SITE ELECTRICAL DEMOLITION PLAN
TRAFFIC OPERATIONAL IMPROVEMENTS
AT VARIOUS LOCATIONS
Vicinity of Kamehameha Highway and
Lumiaina Street
Project No. 99C-01-13
Scale: As Noted Date: Jan 2014
SHEET No. E-002 OF 9 SHEETS

SITE ELECTRICAL PLAN
TRAFFIC OPERATIONAL IMPROVEMENTS
AT VARIOUS LOCATIONS
Vicinity of Kamehameha Highway and
Lumiana Street
Project No. 99C-01-13
Scale: As Noted Date: Jan 2014
SHEET No. E-003 OF 9 SHEETS

TRAFFIC OPERATIONAL IMPROVEMENTS  
AT VARIOUS LOCATIONS  
Vicinity of Kamehameha Highway and  
Lumiaia Street  
Project No. 99C-01-13  
Scale: As Noted Date: Jan. 2014  
SHEET No. E-004 OF 9 SHEETS

"AS-BUILT"

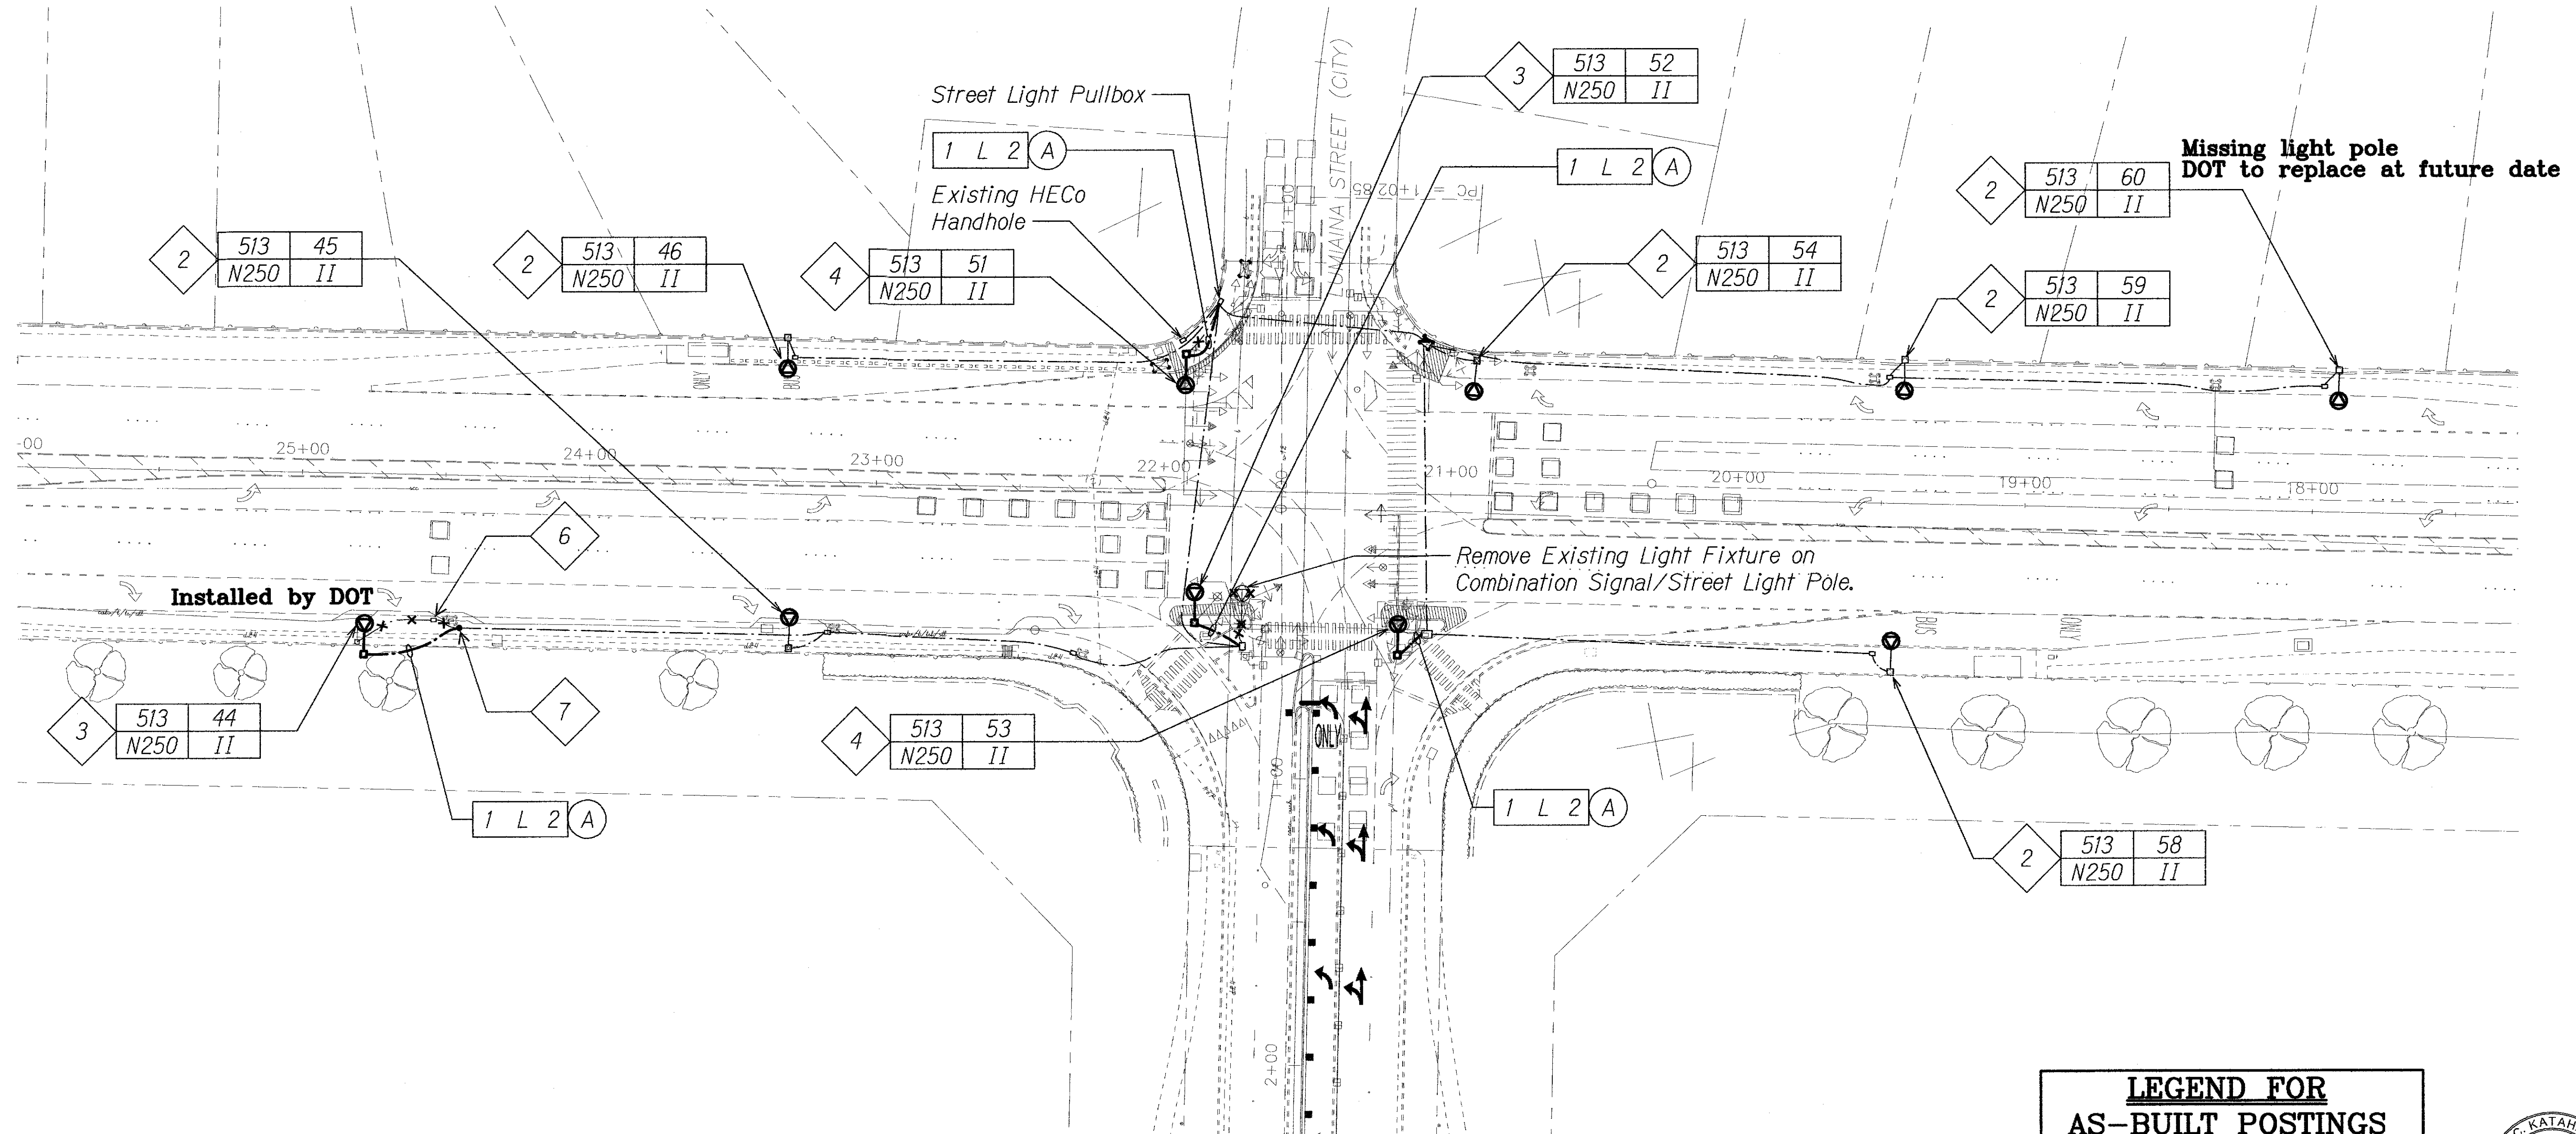
- Light Lines Denote Existing Condition
Bold Lines Denotes New Work
- Remove Existing Light Fixture. Provide New 250W HPS Type II Cut-Off Flat Lens on Existing Bracket Arm, and Connect to Existing Wiring.
- Provide and Install New 250W HPS Type II Cutoff Flat Lens on New Street Light Pole. See Detail ~~E-004~~ ~~E-009~~ for Street Light Standard Details. Deleted
- Remove Existing Light Fixture From Pole. Provide and Install New 250W HPS Type II Cut-Off Flat Lens on New Combination Sig/St Light Pole. Refer to State Hwy Standard Plan TE-38 for Type III Traffic Signal Pole Details.
- For Clarification of Street Light Renovations, Reference Street Light One-Line Diagram on Sheet **E-008**.

- ~~Demolish Exist Pullbox That is Paved Over. Deleted~~
- ~~Intercept Exist Conduit & Extend to New Light Pole. Provide New Wiring Back to Pole 45. Deleted~~
- Provide New Street Light I.D. Tag on Each Pole. Refer to **C** ~~E-004~~ **E-009** for Details.
